IEEE Std 4a-2001
*(Amendment to
IEEE Std 4-1995)*

Amendment to IEEE Standard Techniques for High-Voltage Testing

Abstract: *This amendment sets forth a number of clarifications and corrections to IEEE Standard Techniques for High-Voltage Testing.*

Figure 1.3—Humidity correction factor k as a function of absolute humidity
(For applicability, see 1.3.4.3 and Table 1.3)

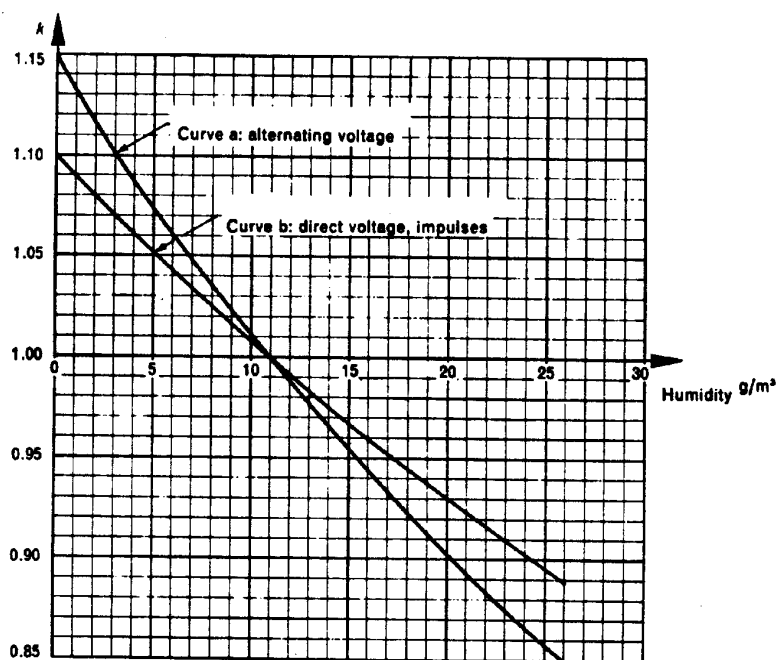
The constant k is given in Figure 1.3 as a function of absolute humidity, curve a or b being applicable according to the type of voltage. The exponents m , n , and w depend on the type and polarity of the voltage and on the flashover distance d as given in Table 1.3 and Figure 1.4. Lacking more precise information, m and n are assumed to be equal.

NOTE—In Table 1.3, Figure 1.3, and Figure 1.4, a simplification of the existing information is given. The available experimental data from different sources always show large dispersions and are often conflicting; moreover, relevant information for direct voltages, and for switching impulses is scarce. The correctness of using equal exponents m and n , and of their numerical values as given, is therefore uncertain.
